Attachment 1: <https://engage.vic>

**Suburban Rail Loop East Environment Effects Statement and Planning
Scheme Amendment.
Bayside City Council - Submission**

This submission is made by Bayside City Council in response to the exhibited Environmental Effects Statement (EES) for the Suburban Rail Loop East Project and draft planning scheme amendment GC197 (Amendment GC197).

TA K1. 6.2.3 Groundwater levels and flow

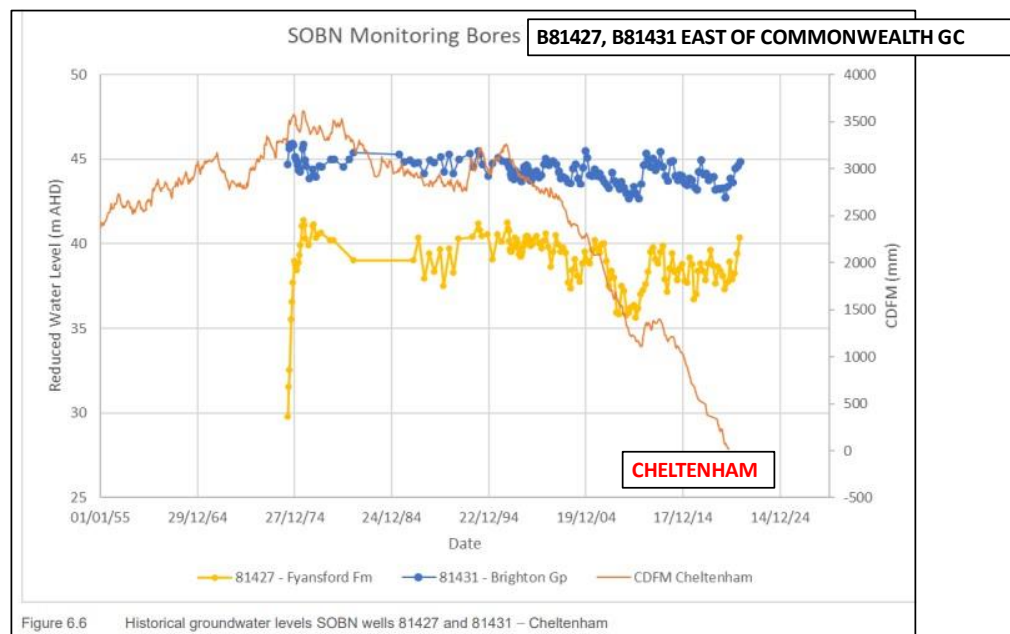
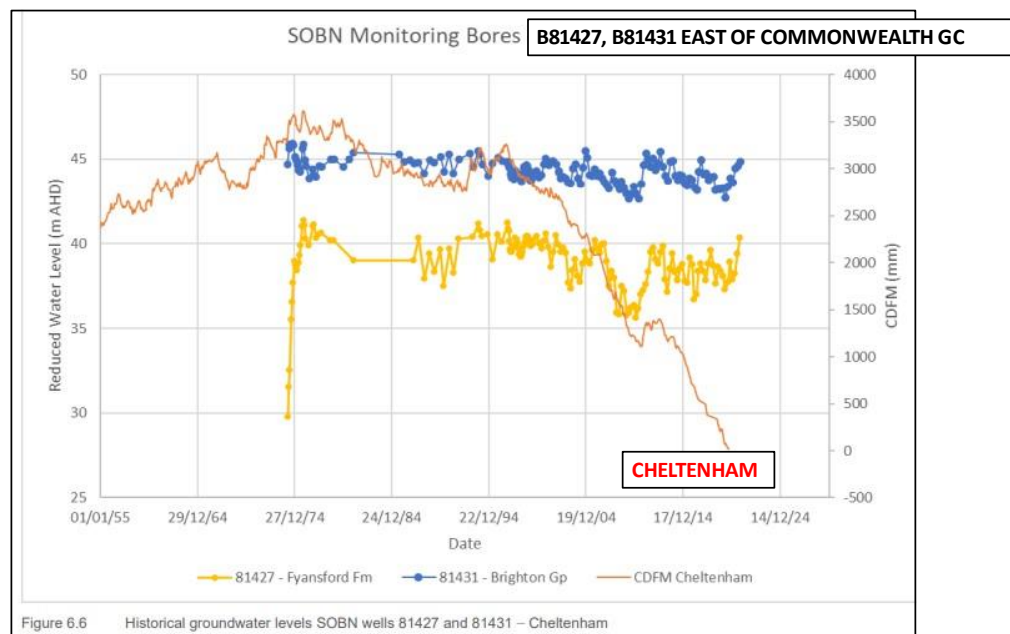
Design groundwater levels for the Project over the next 100 years have been estimated taking account of the influence of sea level rise, reduced rainfall/recharge, higher evapotranspiration, as well as changes due to infrastructure such as sewers. A maximum groundwater level rise of 2.5 m has been estimated over the design life of the Project.

Nested SOBN bores approximately 5 km north-west of the SRL station at Cheltenham have been monitored since the 1970s and highlight a long-term declining trend in groundwater level in all aquifers since the 1970s (see Figure 6.6 BELOW). The magnitude of decline is fairly similar between aquifers (~1.5 m) and is consistent with the decrease in rainfall over the period November 1979 to May 1988. The decline is consistent with rainfall trends over that time.

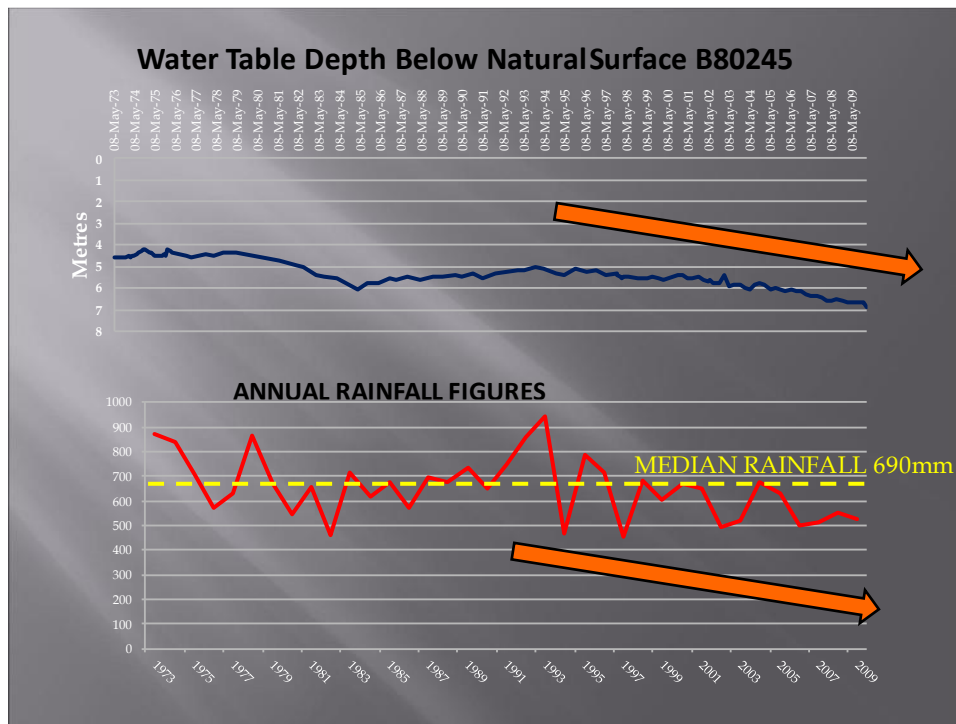
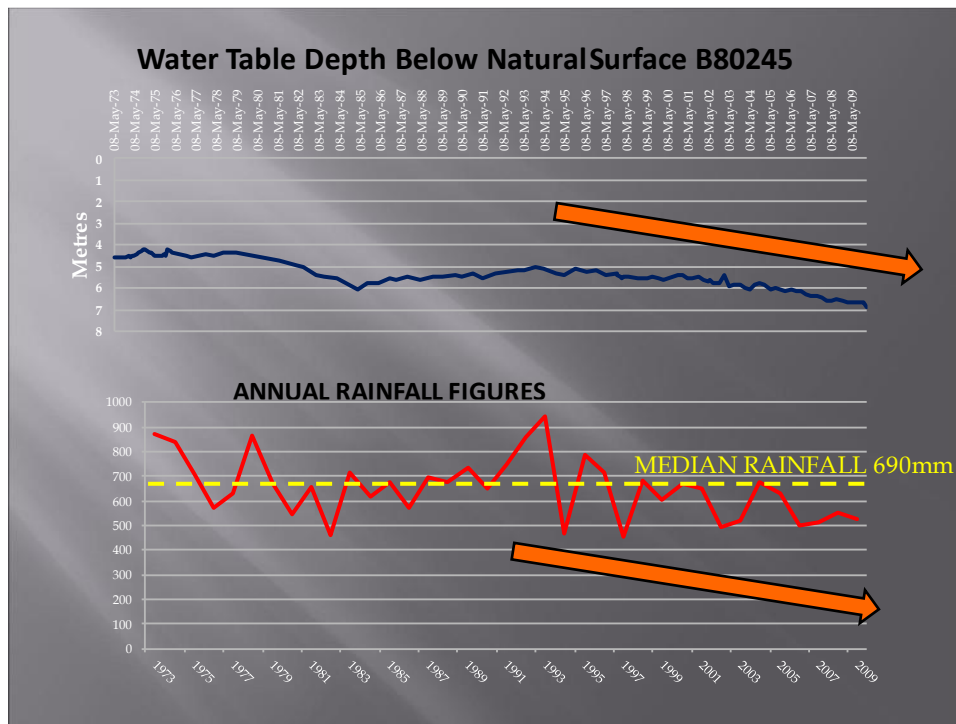
This rate of drop is mirrored in State Observation Bore B80245 in Beaumaris. (Groundwater readings available 1973 to 2009). See figure below.

On our golf courses, borefield measurements show that in years with below average rainfall the water table continues to drop. Only in high rainfall years, such as 2010, 2011, does recovery occur. Since the 1960's, some 50 years ago, when we have records of SWLs in our bores, the water table has steadily dropped in line with both Figure 6.6, and Observation Bore B80245 above.
